**Economic and Social Council**Distr.: General
24 November 2017

Economic Commission for Europe**Inland Transport Committee****World Forum for Harmonization of Vehicle Regulations****Working Party on Passive Safety****Sixty-second session**

UN Regulation No. 129 (Lateral collision)**Proposal for Supplement 4 to the 01 series of amendments to
UN Regulation No. 129 (Enhanced Child Restraint Systems)****Submitted by the expert from France***

Figure 2

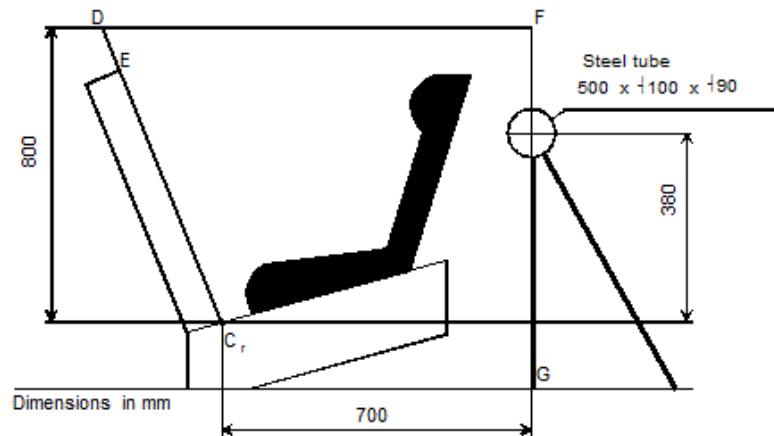
Paragraph 6.6.4.4.1.2.1, amend to read:

"6.6.4.4.1.2.1. Head excursion: no part of the head of the dummy shall pass beyond the planes FD, FG and DE, as shown in figure 2 below. This shall be judged up to 300 ms or the moment that the dummy has come to a definitive standstill whatever occurs first.

Except when testing using Q6 or Q3 dummy where the value in relation to the FD plane is 840 mm.

Where a test is conducted with paragraphs 6.6.4.1.6.1.1.2., **6.6.4.1.6.1.2. or paragraph 6.6.4.1.8.2.** above, only the second configuration test results without 100 mm diameter bar will be considered.

"Annex 2

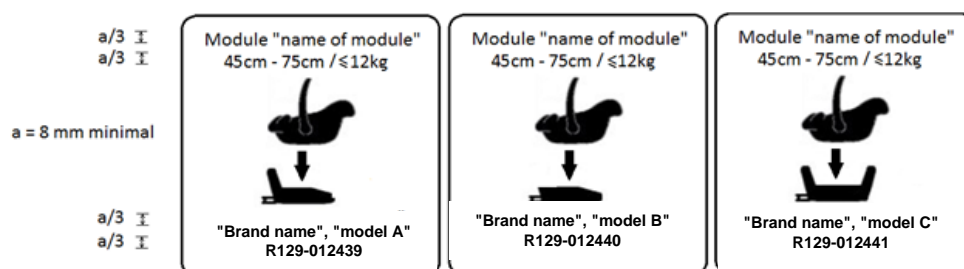
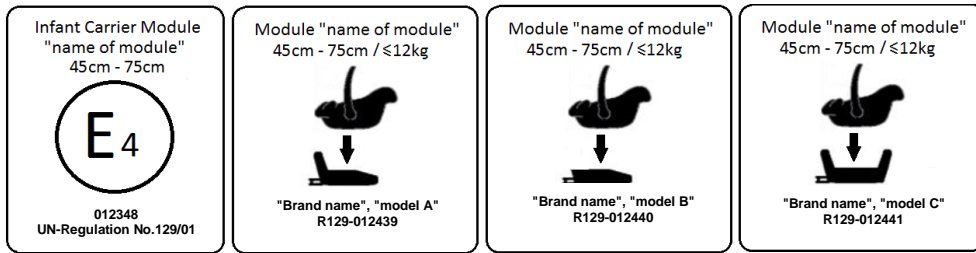
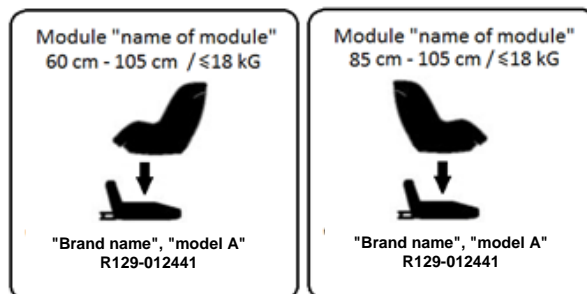
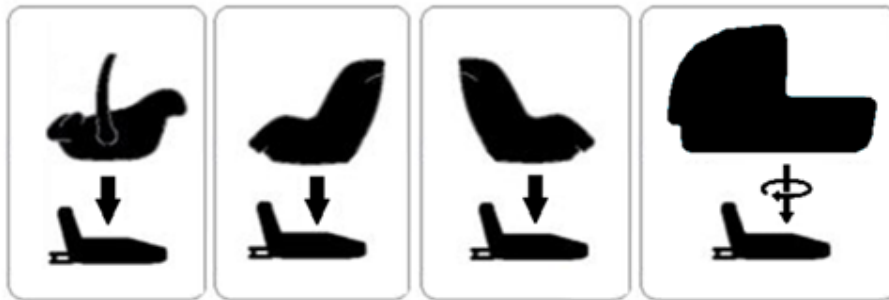
Annex 2, replace current Annex 2 by the following to read:

1. Arrangements of the approval mark
...
2. Arrangements of the approval mark in combination with a module mark
...
- 2.1. Arrangements of the module mark in combination with an approval mark
- 2.1.1. Where a module is approved for use with more than one base, the individual base and module combinations shall be indicated on the module in separate module marks, each bearing their applicable size ranges.

An Enhanced Child Restraint System that bears an approval mark for the stand-alone mode of use and a module mark for its use on three different bases, shall carry the following arrangement of approval and module marks:

- 2.1.2. Where a module is capable of being installed in different orientations, separate module marks shall be indicated on the module, each bearing their applicable size ranges.

- 2.2 Examples of the symbols to be used on the module mark are given in the figures below. As chosen by the Enhanced Child Restraint Systems manufacturer, one of the symbols or an equivalent shall be used on the module mark.

Figure 1
Procedure type 1

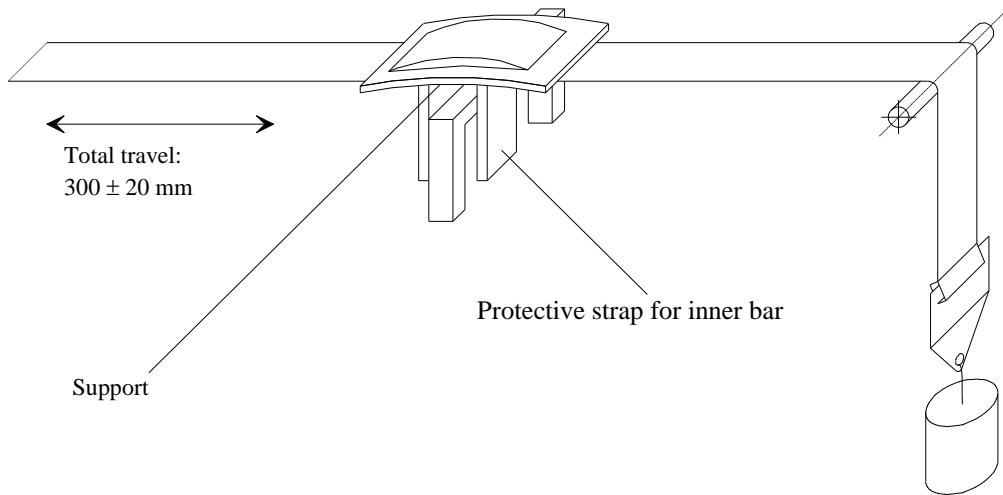
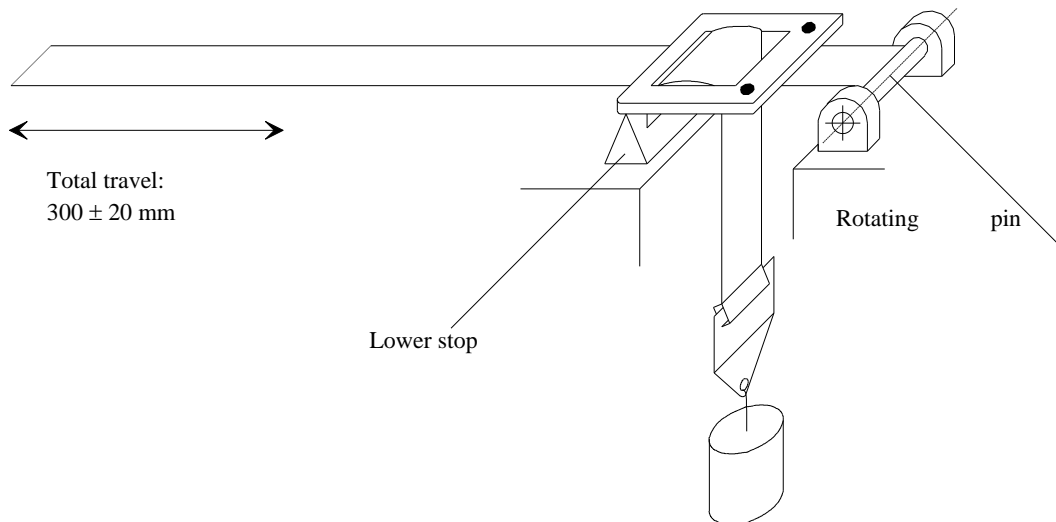
Annex 5, Figures 1 and 2 , amend to read:

$F = 10 \pm 0.1 \text{ N}$, can be increased up to $F = 60 \pm 0.5 \text{ N}$ (see table 8, paragraph 7.2.5.2.6.2.)

$F = 10 \pm 0.1 \text{ N}$, can be increased up to $F = 60 \pm 0.5 \text{ N}$ (see table 8, paragraph 7.2.5.2.6.2.)

Figure 2
Procedure type 2
 Following two examples of test set up

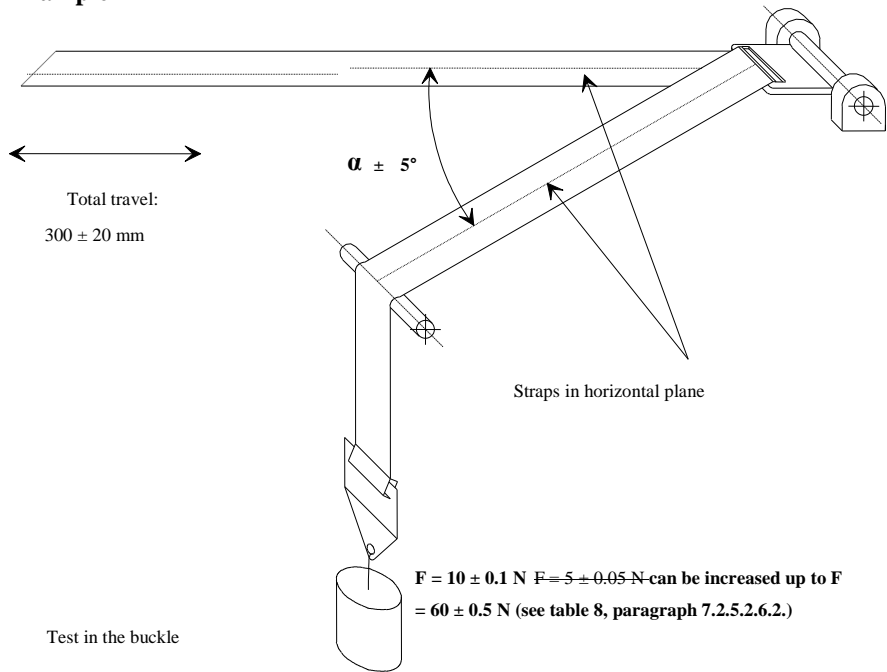
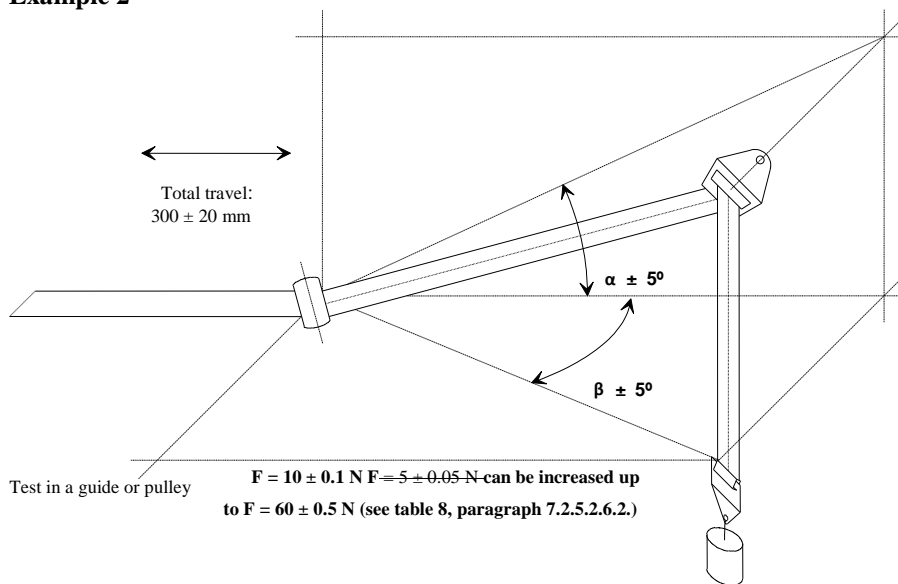
Where α and β reproduce the angles as in the real installation (in three dimensions)
 ..."

Figure 3
Side and Front View of the measuring device for measurements applicable to Enhanced Child Restraint Systems that feature an impact shield

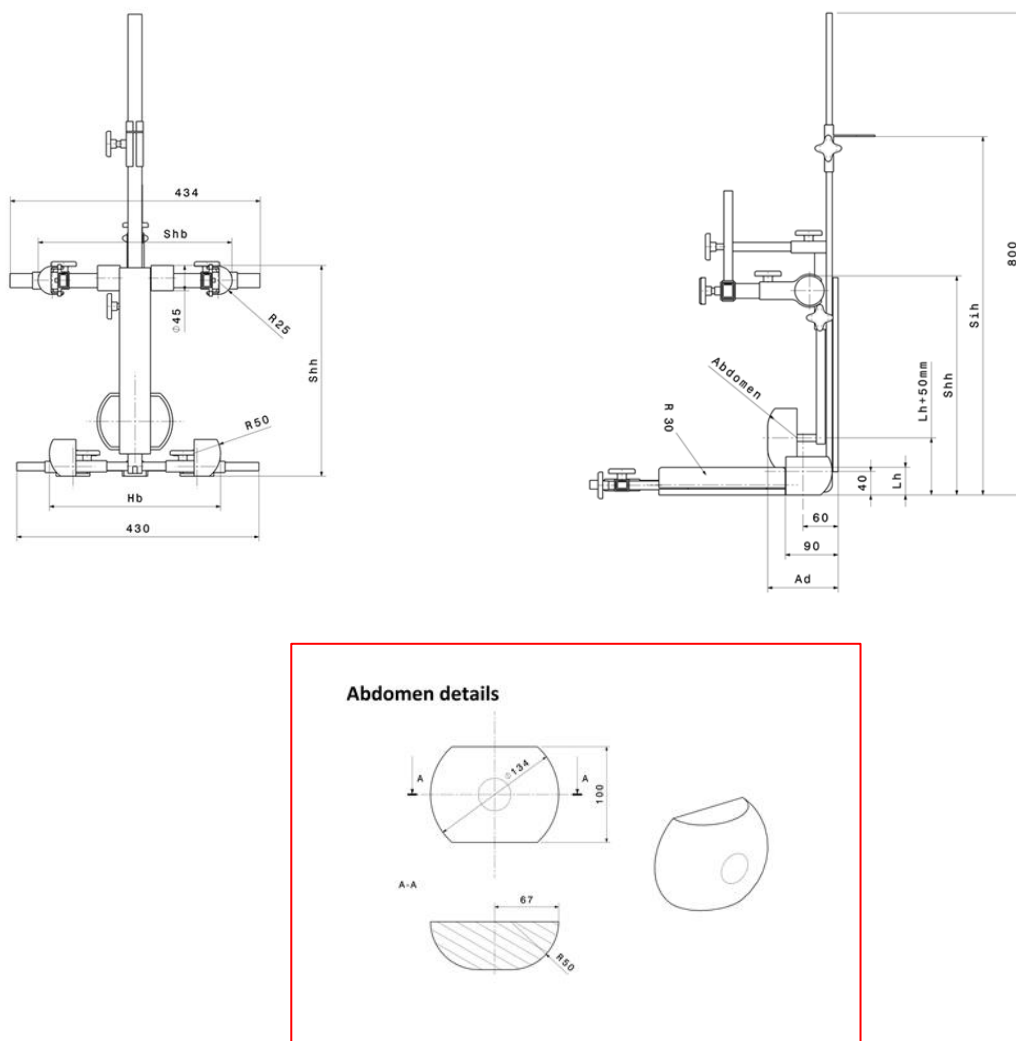
Annex 18, amend to read:
